UNITED STATES PATENT AND TRADEMARK OFFICE

10/552,986

Office Action Summary	Application No. 10/552,986	Applicant(s) BREKKE, TOR	
	Examiner Cassey Bauer	Art Unit 3744

DETAILED ACTION

Reference 1

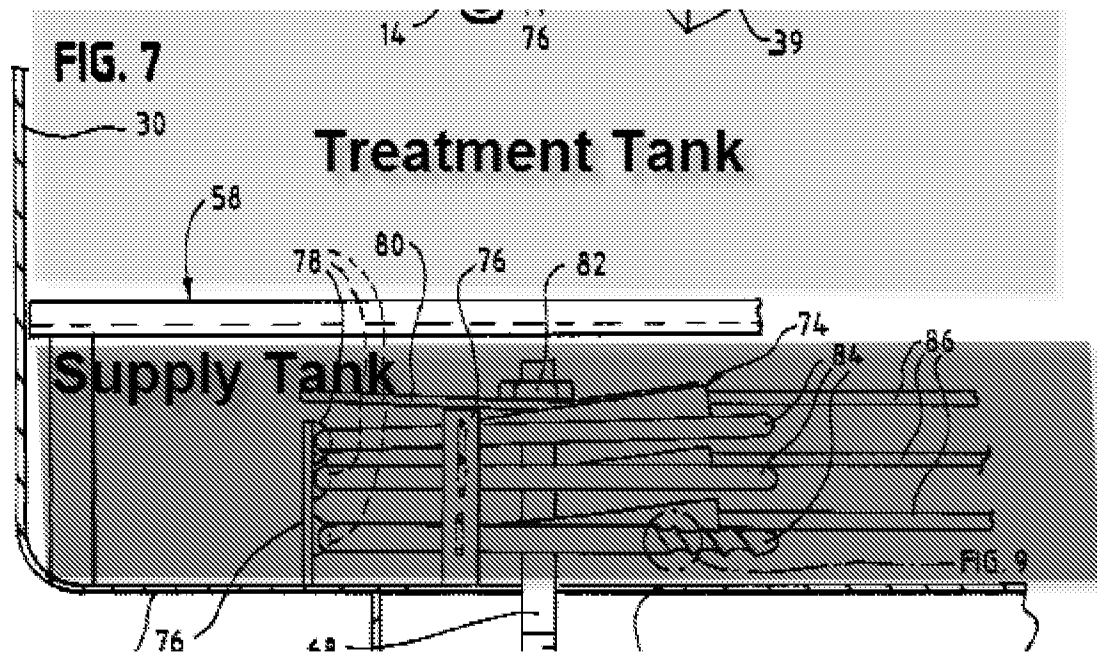
Clark, Miller and Goldstein fail to specifically disclose when the temperature of the ice slurry reaches approximately 0.5 degrees Celsius, additional ice slurry is introduced into the treatment tank from a supply tank in which the ice slurry is prepared with an adequate ratio of ice particles from an ice machine. One skilled in the art would understand that adding additional ice slurry to the tank is an obvious mechanical expedient for increasing the temperature of the tank. It is also a well known concept to have a set point for a refrigeration system when the temperature in the tank is above the set point, to provide additional cooling to the tank to maintain the set point in the tank. Further, one skilled in the art would recognize that when freezing a product, one would wish to keep the tank environment below the freezing point of water. Therefore, it would have been obvious to one having ordinary skill in the art at the time the invention was made, to modify the system of Clark, Miller and Goldstein to include a set point slightly above freezing (i.e. .5 degrees Celsius) and provide additional ice slurry into the tank from a supply tank, as defined in Reference 1 below, when the temperature exceeds this set point in order to ensure that the temperature of the tank remains below freezing when it is desired to freeze the items introduced into the tank.

In reference to claim 26, Clark, Miller and Goldstein disclose the claimed invention.

Clark, Miller and Goldstein fail to teach wherein the ice slurry is circulated between a number of treatment tanks for product units in series or in parallel and an ice slurry supply tank for tempering of the product units.

However, the treatment tank (16) of Clark is an essential working part in that without it, there would be no means for holding the ice slurry and the food product and the system would fail to work as intended. Applicant should note that it has been held that mere duplication of the essential working parts of a device involves only routine skill in the art. Further one skilled in the art would recognize that by providing a number treatment tanks in either series or parallel to each other, that one ice forming tank (as defined in Reference 1 above) could be utilized to cool multiple types of food products which require varying
